HARTING Product Change Notification

PCN/16/028/PM+MD

Product range: DC1 / DIN Power

Title: New appearance of coding bar - External

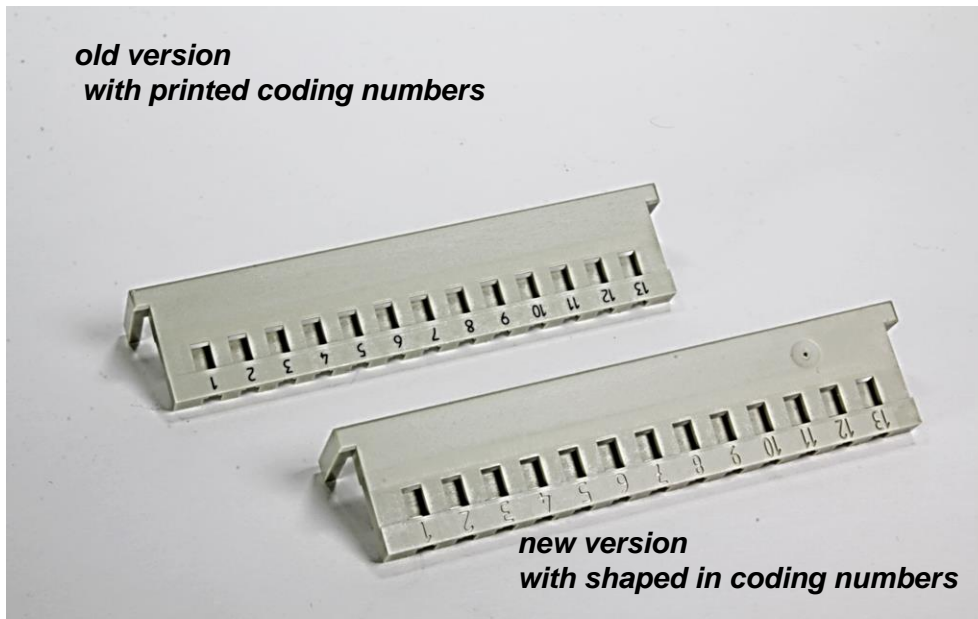
2. Description of changes / news:

There is no impact on the specification and no change of dimensions.

- Old revisionlevel 01 -> New revisionlevel 02
